Rezoning Transportation Analysis

Petition Number: #2022-096

| Date | Description |
|----------|--------------------|
| 11-28-22 | First Review (TM) |
| 7-28-23 | Third Review (ME) |

Reference (GLDSM standard detail U-05A and U-03A) for street typical.

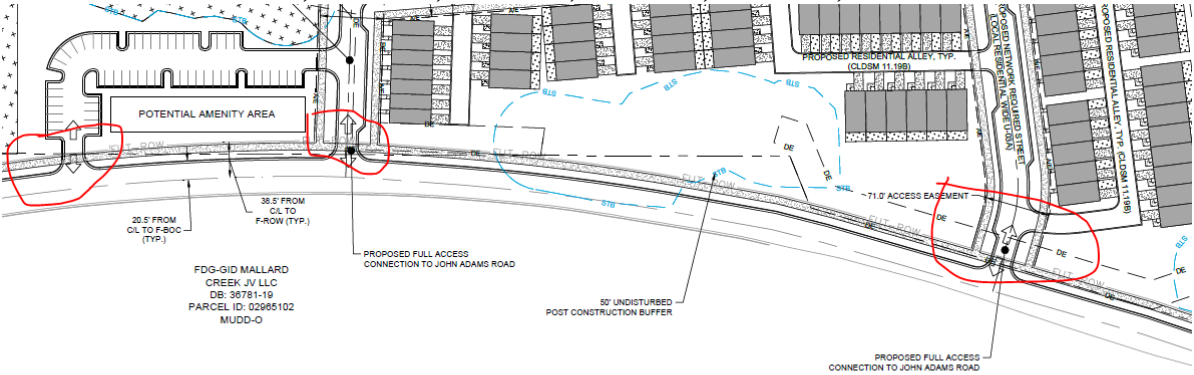
6. ~~The proposed dwelling units exceeds 12 per acre. Per Chapter 20 Subdivision ordinance, site plan and conditional note(s) revisions are needed to commit to construct an 8-foot planting strip, and 8-foot sidewalk along John Adams Road, Galloway Road and all internal network required public Streets. The wider sidewalk also meets the Charlotte WALKS Policy.~~

~~**Clarifying comment 6.21.2023:** Label and dimension 8-foot planting strip and 8-foot sidewalk on all internal public streets.~~
